NRC DOCKET NUMBERS 50-424 AND 50-425
CONSTRUCTION PERMIT NUMBERS CPPR-108 AND CPPR-109
VOGTLE ELECTRIC GENERATING PLANT - UNITS 1 AND 2
SER CONFIRMATORY ITEM 44: PROCEDURES GENERATION PACKAGE

In the SER your staff requested to review the VEGP EOP's deviations from the ERGs. Enclosed are the deviations noted in our review along with the appropriate justifications.

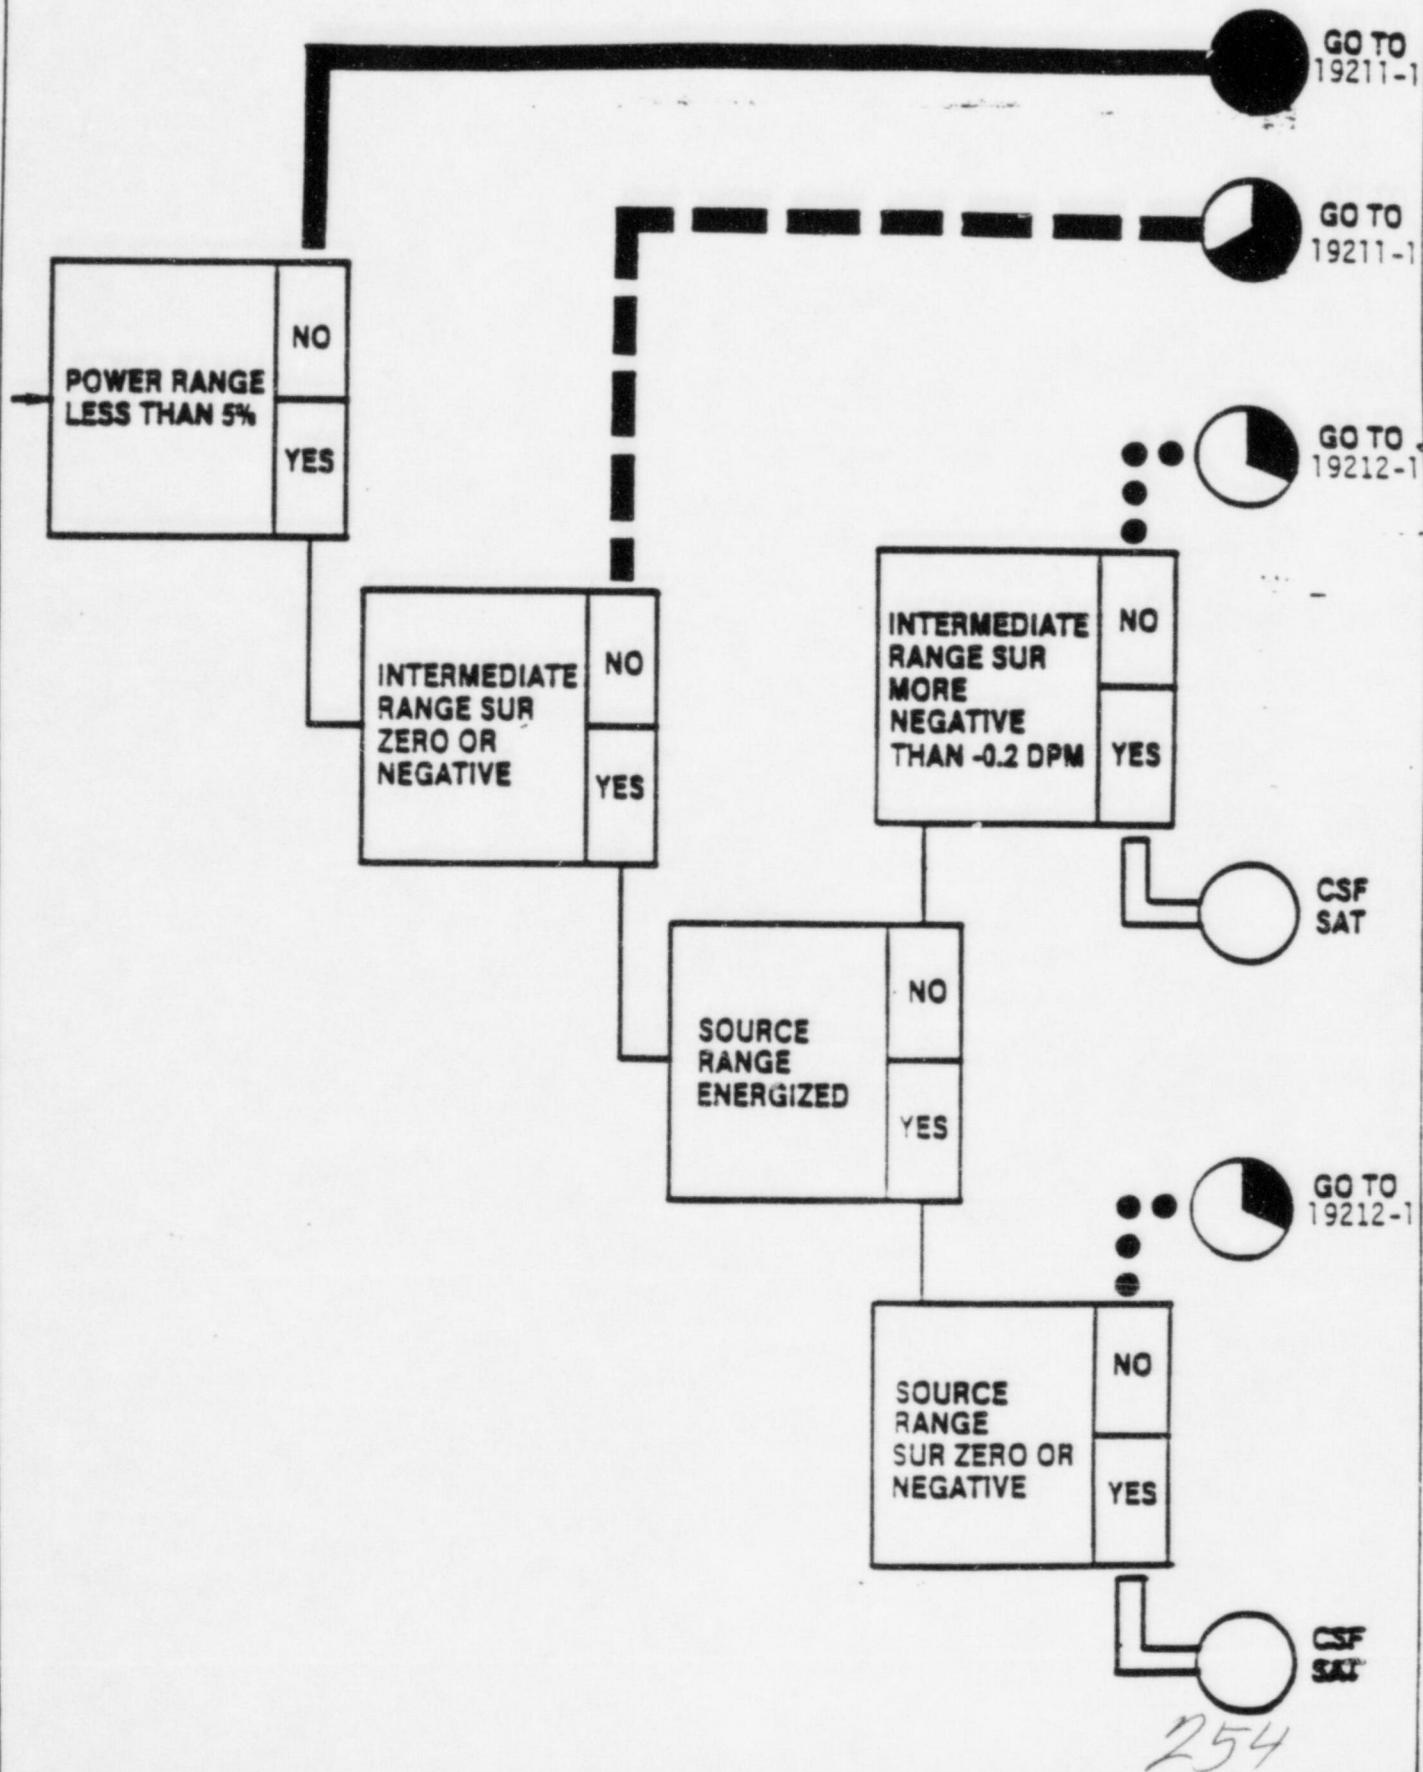
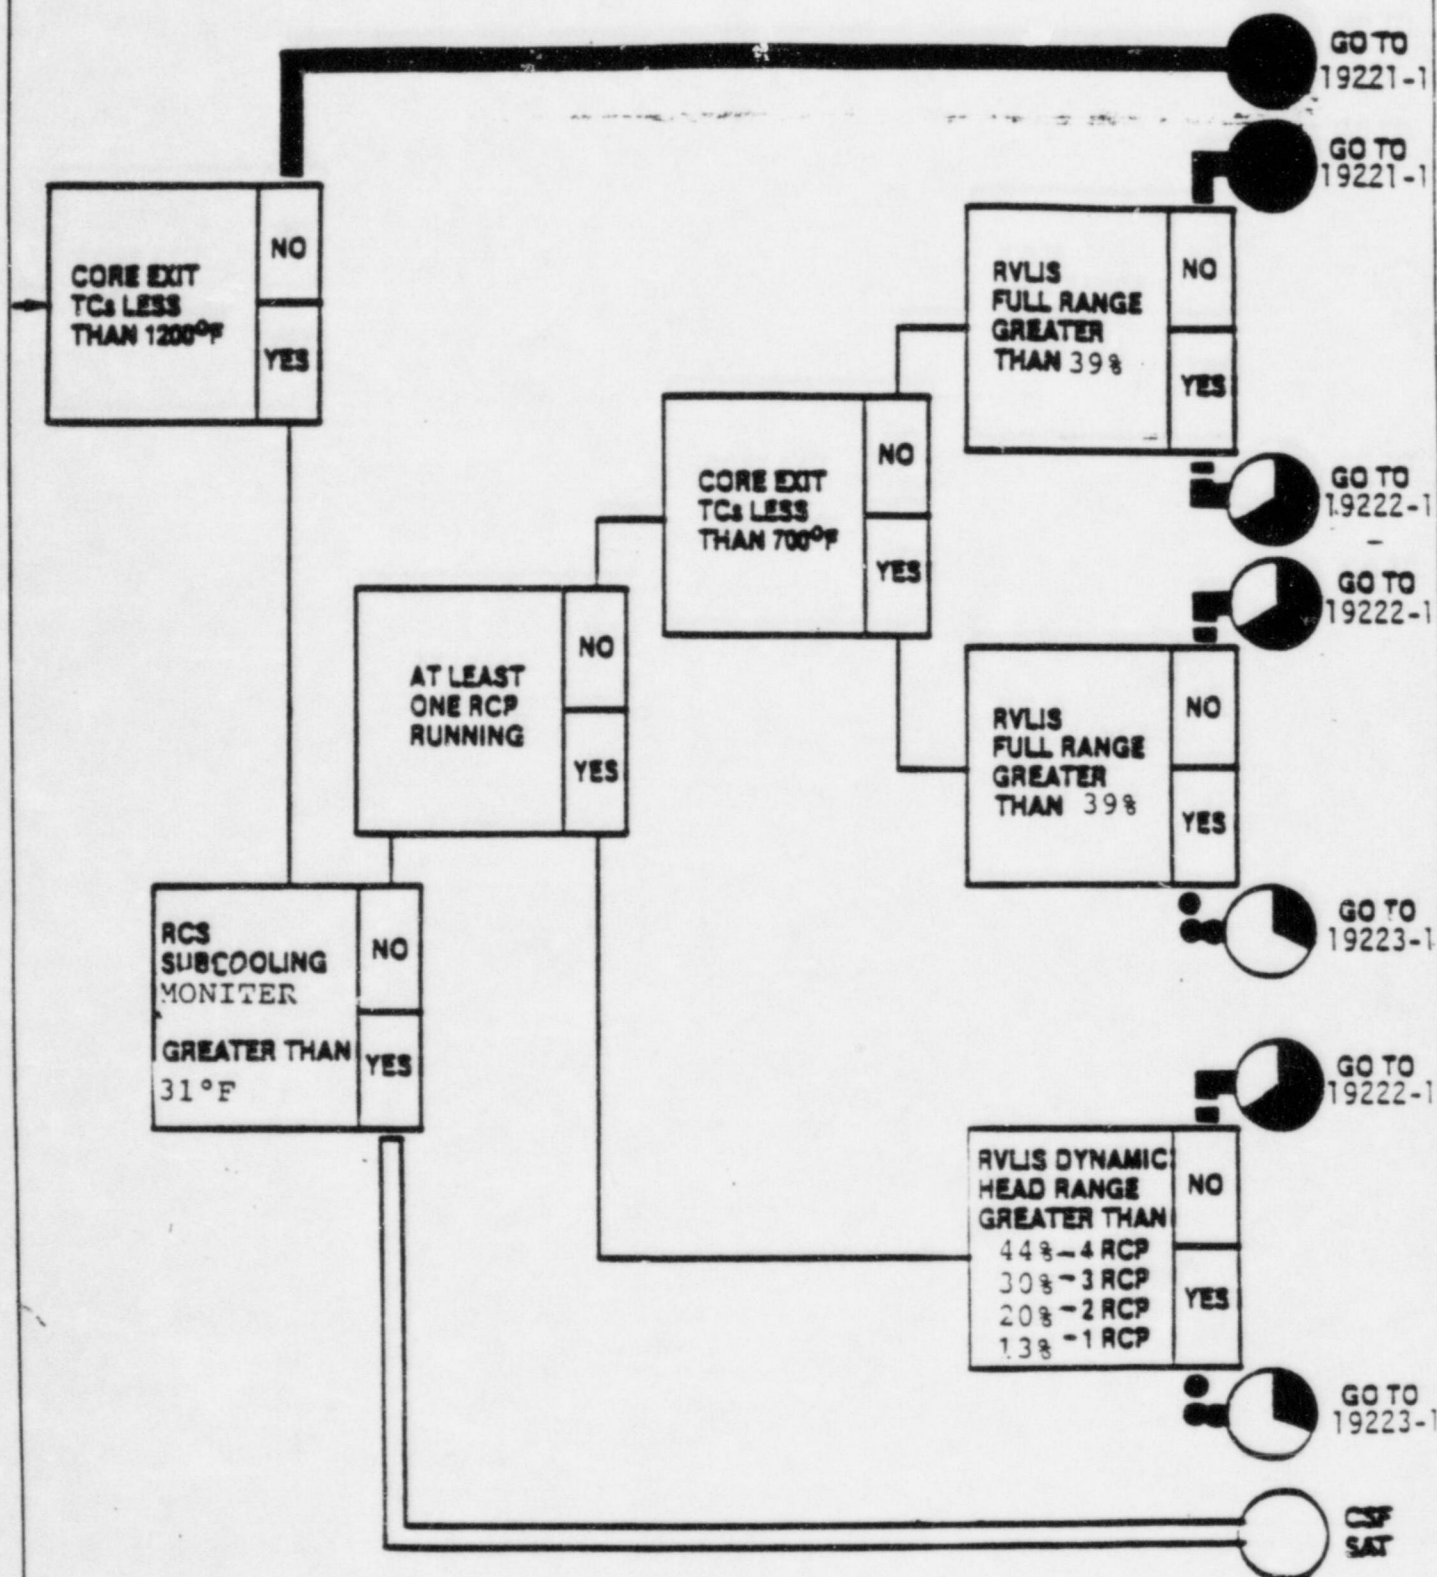
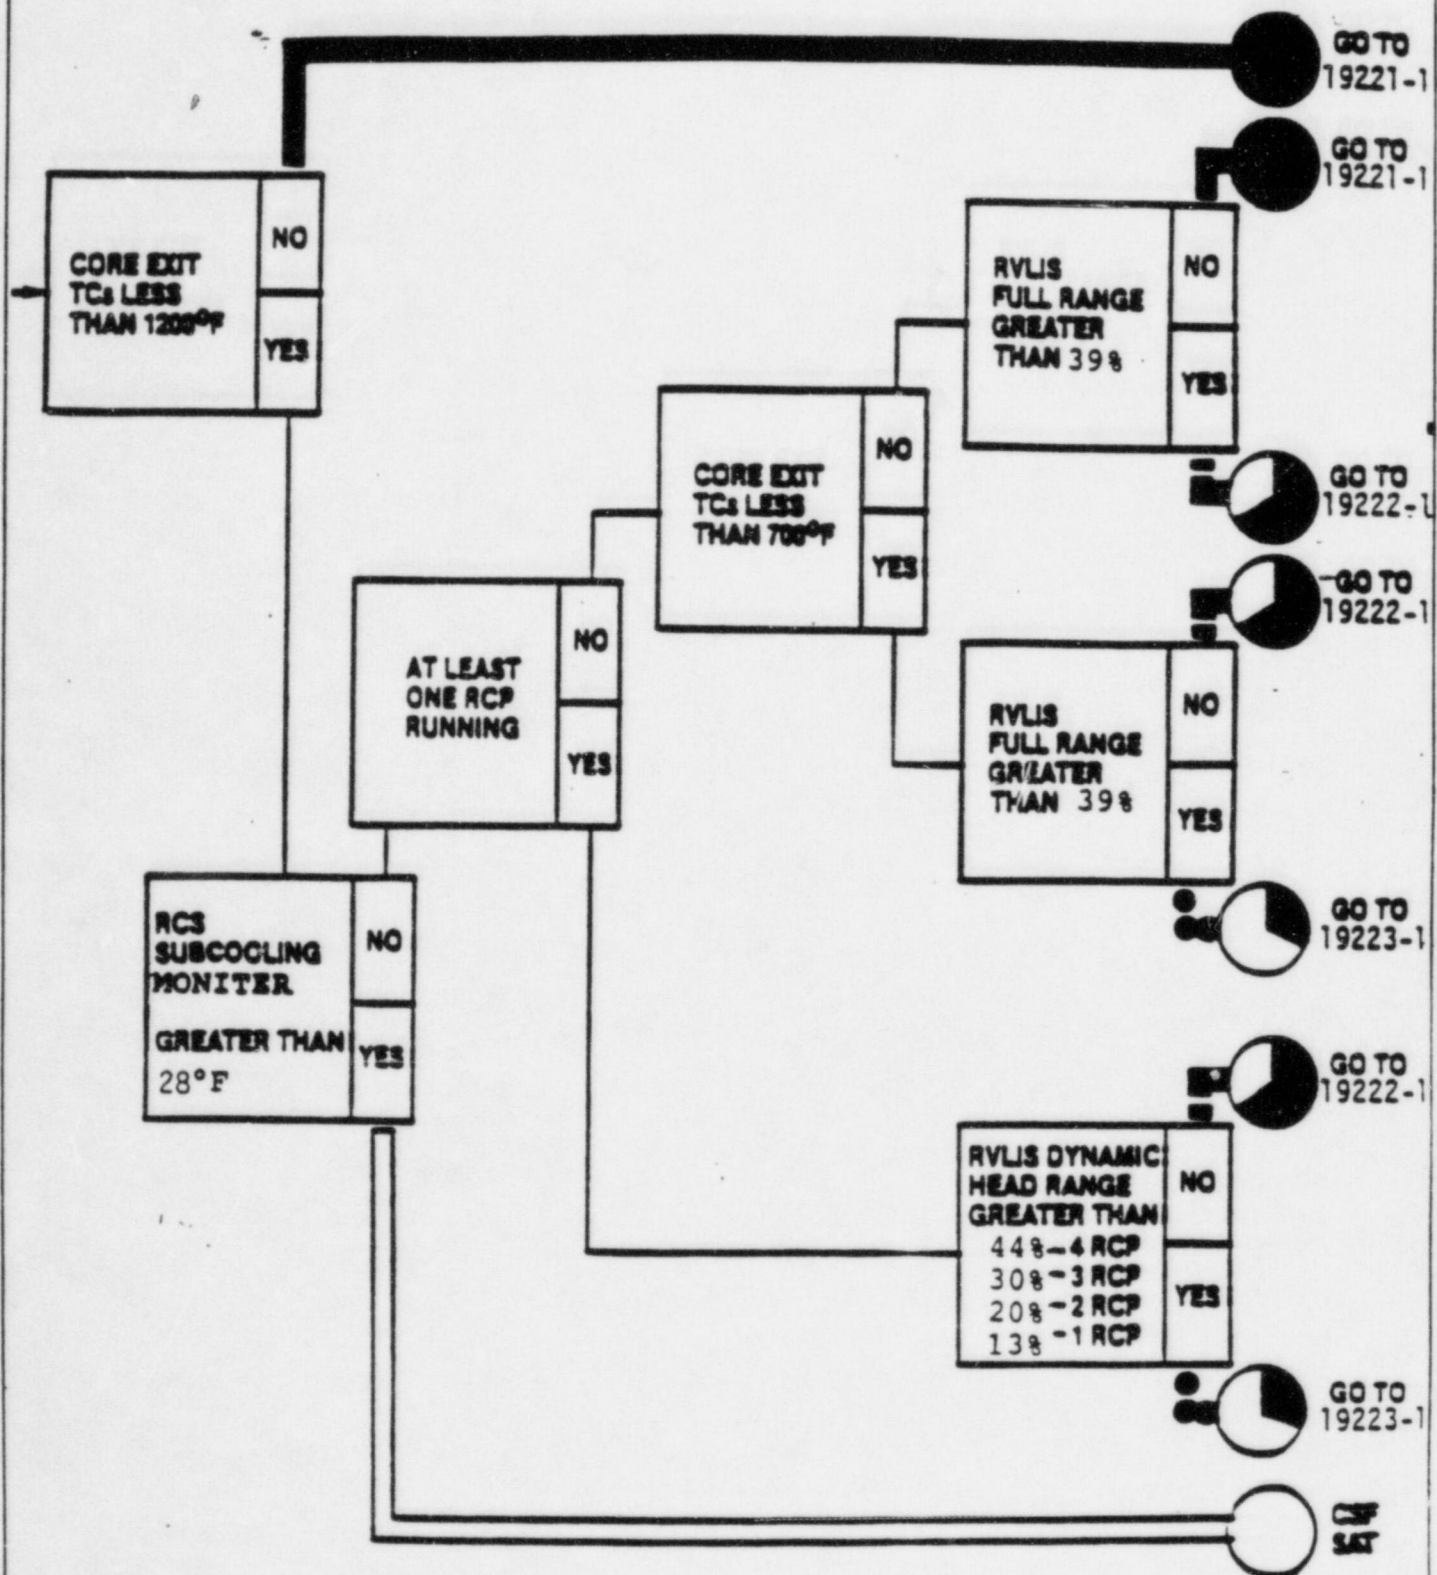
Plant specific
values and VEGP EOP
identification was included.
